SUBJECT: Responds to concerns raised during 891113-1204 insp re
 environmental qualification-terminal boxes & splices.

AEP:NRG:0775AQ

Donald C. Cook Nuclear Plant Units 1 and 2
Docket Nos. 50-315 and 50-316
License Nos. DPR-58 and DPR-74
ENVIRONMENTAL QUALIFICATION-TERMINAL BOXES AND SPLICES

December 20, 1989

FIG. 7

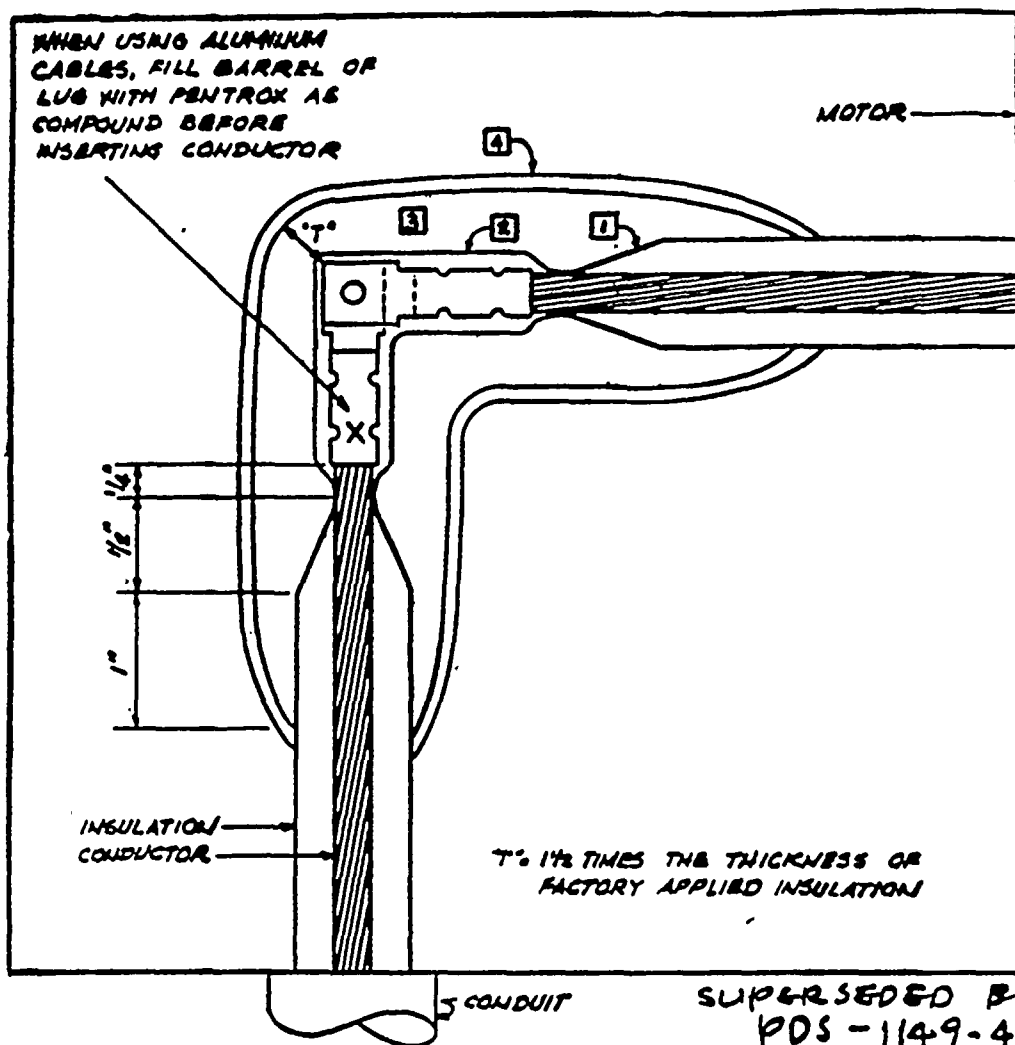
Although the test report makes no mention of the Neoprene tape, the following consideration are nevertheless relevant:

- 1) The test program was undertaken specifically for AEP, to test AEP standard connections.
- 2) The test report specifically states that motor connections were made in accordance with AEP standard drawing 1-2-EDS-613-2.
- 3) 1-2-EDS-613 Revisions 1 and 3, (Figures 7 and 8), clearly indicate that the fourth step in the construction of the motor connection is the application of "3 half-lapped layers of Neoprene tape" (AEP Bill of Material 1788 item #695).
- 4) A letter written to D. V. Shaller (Cook Nuclear Plant manager at the time) dated May 19, 1978 (Attachment 1) from the AEP electrical engineer responsible for the test clearly states: "The 'E' series of test samples used Scotch #23 tape for B/M item 692 and the 'F' series of test samples used Bishop W962 for B/M item 692. Both samples used Okonite "Okoprene" Neoprene tape for B/M item 695."

Thus the instructions in the Revision 2 of the standard, refer to the use of generic materials for the motor connections. After the Westinghouse-Canada test qualified the Scotch 23, Bishop W962 and Okoprene tapes, the standard was revised to eliminate the generic instruction and direct that specific manufacturers be used for EQ reasons. The 1-2-EDS-613-3 version is therefore the exact description of what was tested at the Westinghouse Ontario labs.

Whatever the reasons may have been for neglecting to mention the inclusion of the Neoprene tape in the test, the records of 1-2-EDS-613 Revisions 1 and 3 plus Mr. T. E. King letter previously quoted leaves no room for doubt that the Okonite-Okoprene Neoprene tape was environmentally tested and qualified together with the Scotch and Bishop tapes.
